PLANNING COMMISSION MEETING

LOCATION: TOWNSHIP ANNEX, 7527 HIGHLAND ROAD, WHITE LAKE, MICHIGAN, 48383
(FORMER WHITE LAKE LIBRARY)
THURSDAY, JULY 07, 2022 – 7:00 PM

RE: The Avalon- f.k.a. White Lake Hill- Preliminary Site Plan Review – 4th Review

RE: The Avalon
Rezoning and Preliminary Site Plan – Review #4

P-2.4

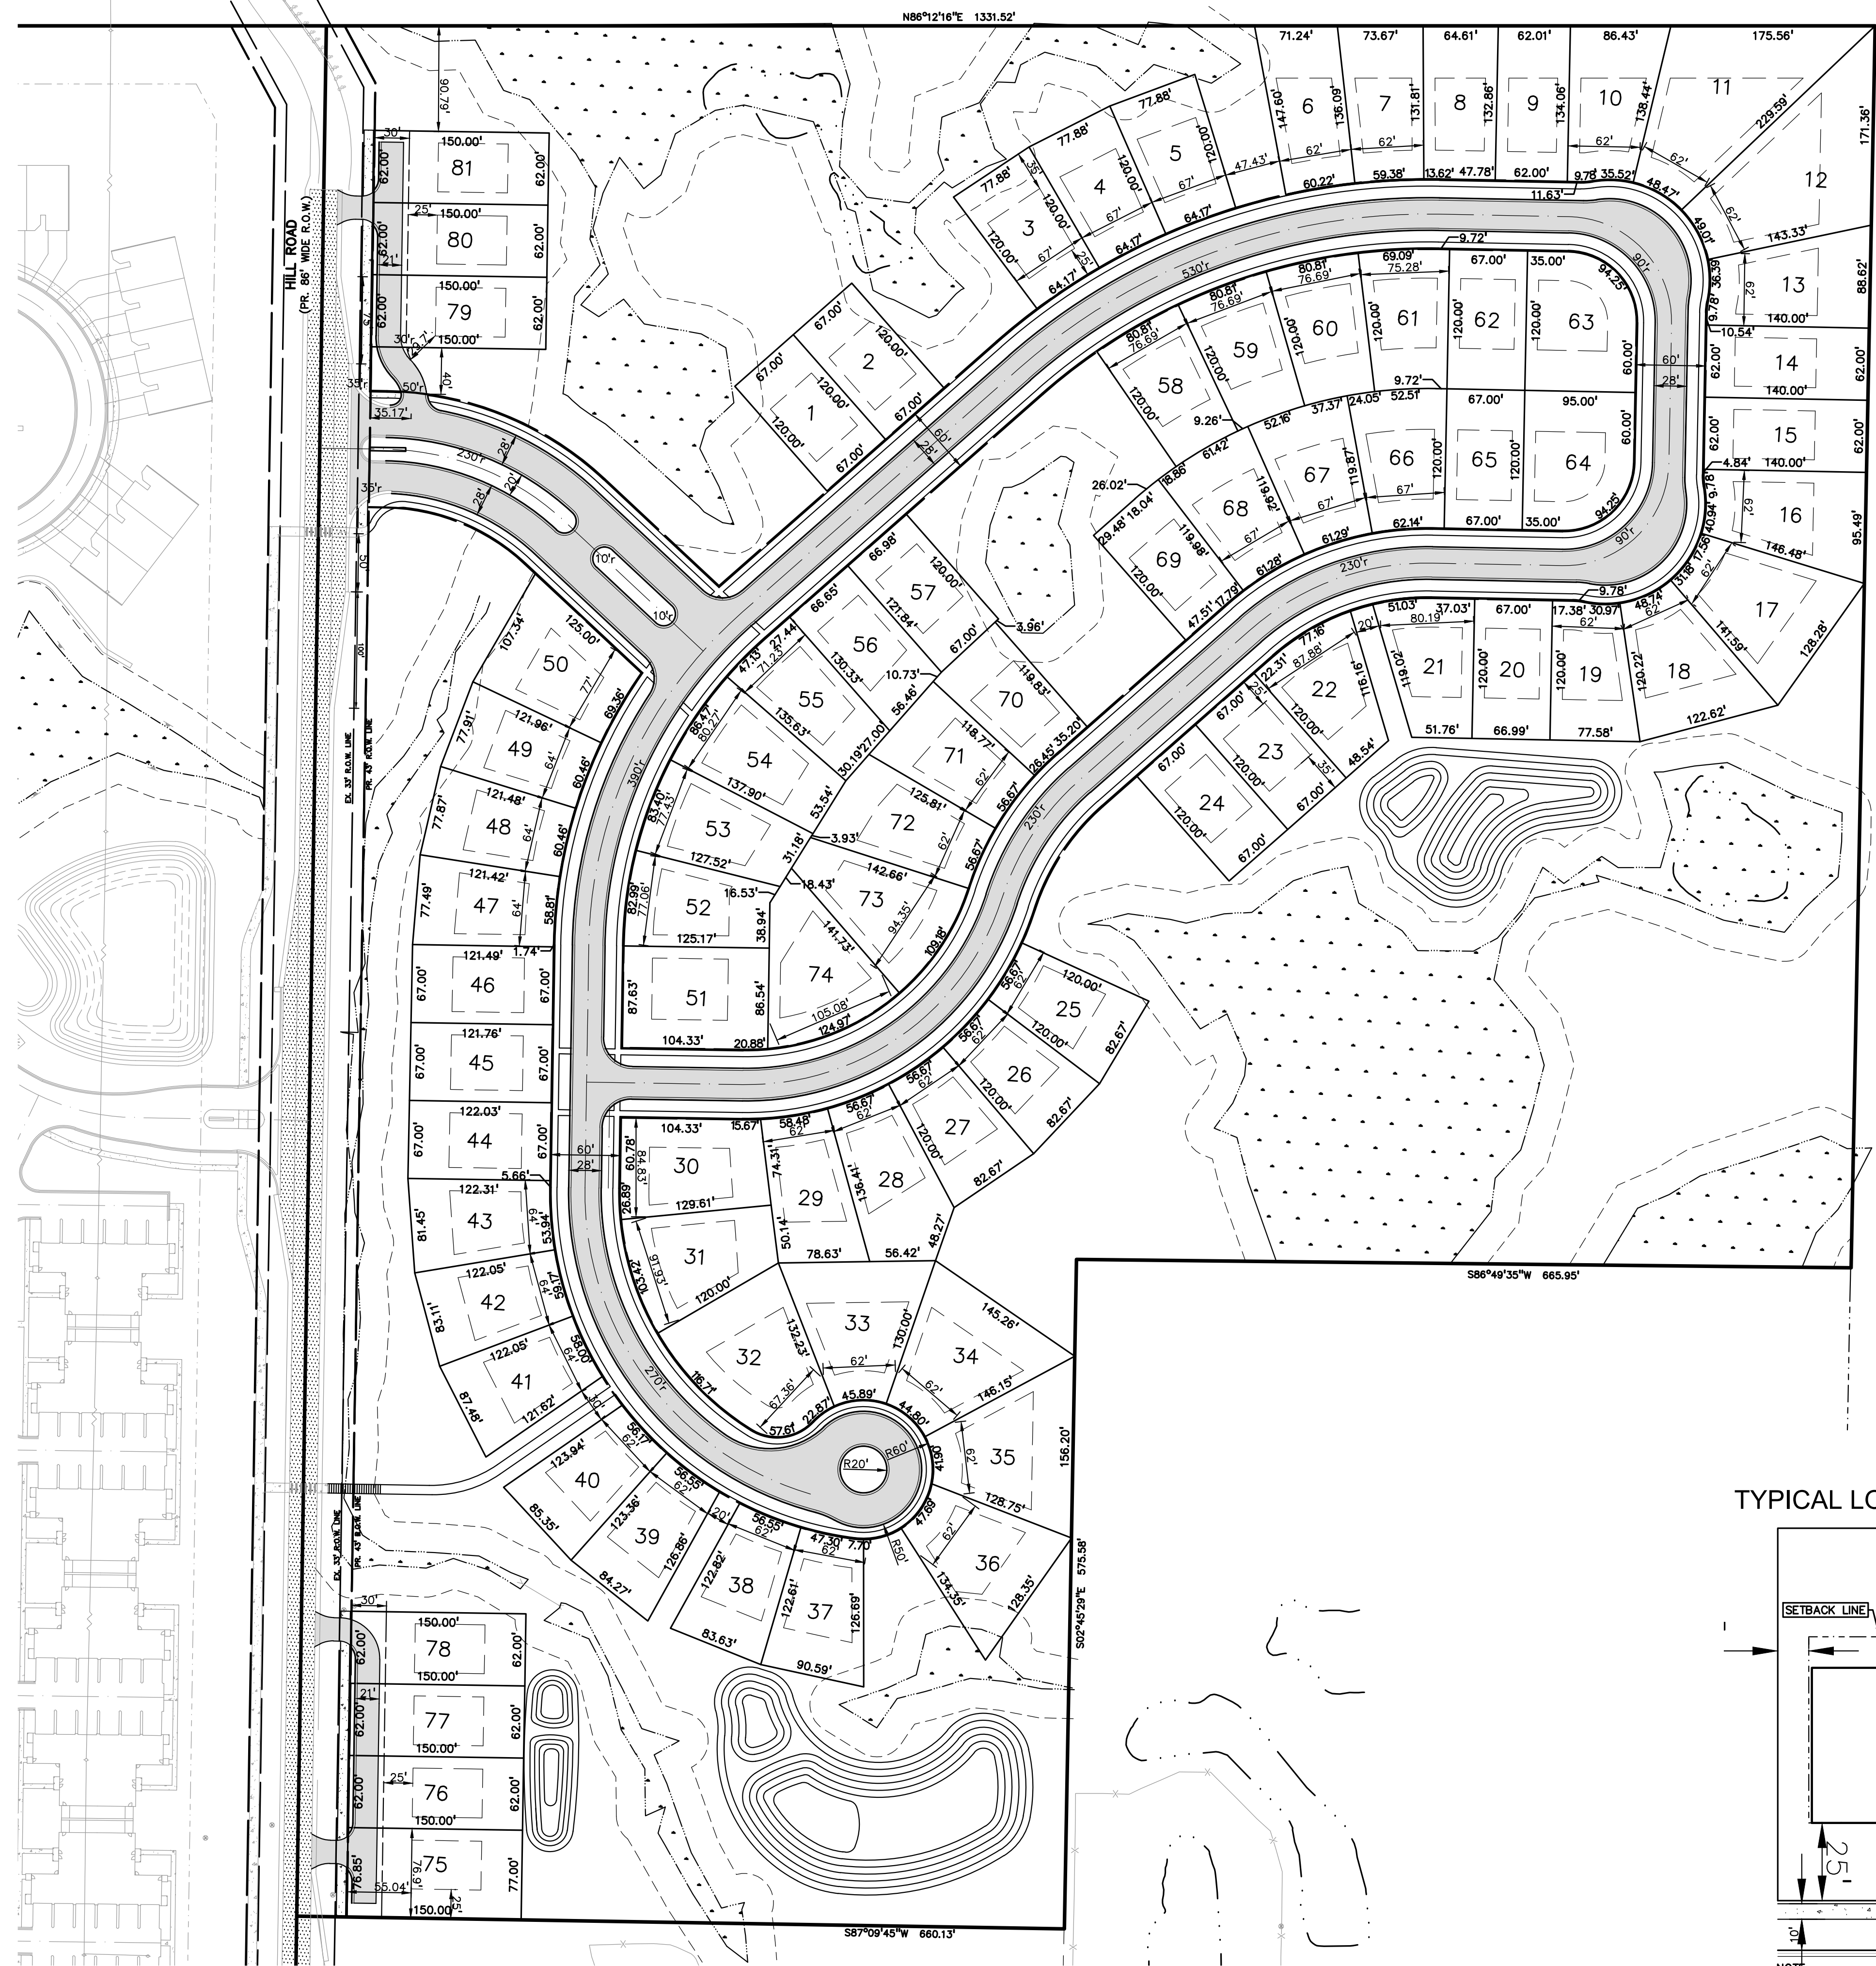
Separate from the waiver request, the note under the typical lot layout on Sheets P-2.3 and P-2.4 of the site plan shall be revised to add the word “within” following the word “encroaching.” Also, the words “wetland buffer” shall be replaced with the words “natural features.” **Comment outstanding.**
